UNITED STATES PATENT AND TRADEMARK OFFICE

APPLICATION NO.	FILING DATE	FIRST NAMED INVENTOR	ATTORNEY DOCKET NO.	CONFIRMATION NO.
10/645,055	08/21/2003	Douglas A. Devens JR.	1001.2346101	6549

Office Action Summary	Application No. 10/645,055	Applicant(s) DEVENS ET AL.	
	Examiner VICTORIA P. CAMPBELL	Art Unit 3763

DETAILED ACTION

Fig. 2b

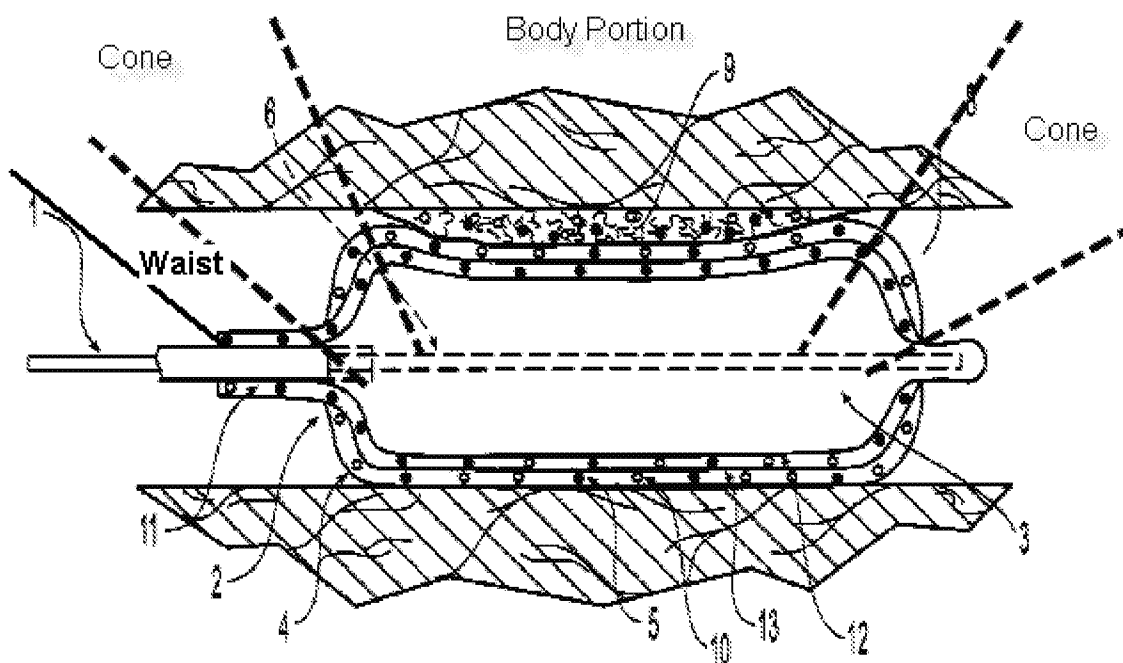
Regarding claims 1-3, 8, 10, and 12 Ding et al disclose a medical device comprising a balloon (3) comprising a first portion having a first length (2), and a second portion disposed on the first portion having a second length (4), wherein the second portion defines an outer surface of the balloon; wherein the first portion varies in thickness along the first length and the second portion varies in thickness along the second length (Figs. 2a, 2b; see right hand side), wherein the balloon has a waist portion, body portion, and a cone portion and wherein the first portion has a greater thickness at the body portion than at the cone portion (Fig. 2b; the body portion of the first portion is thicker than the tapered portion of the right-hand cone portion; see Fig. 2b reproduced below for clarification).

is disposed substantially entirely on the first portion, that the thickness of the first and second portions is generally constant in the cone portion (the tapering of the portions takes place only at the most extreme end of the cone portions, and therefore the thickness is maintained along substantially the entire length), and that the first portion extends substantially the entire length of the balloon (Figs. 2a and 2b). Ding et al fail to explicitly teach or disclose that the thickness of the waist portion of the first portion is less than the thickness of the body portion of the first portion. However, the examiner notes that at the time of invention, it would have been obvious to one having ordinary skill in the art to reduce the thickness of the first portion along the waist portion in order to reduce the profile of the balloon.
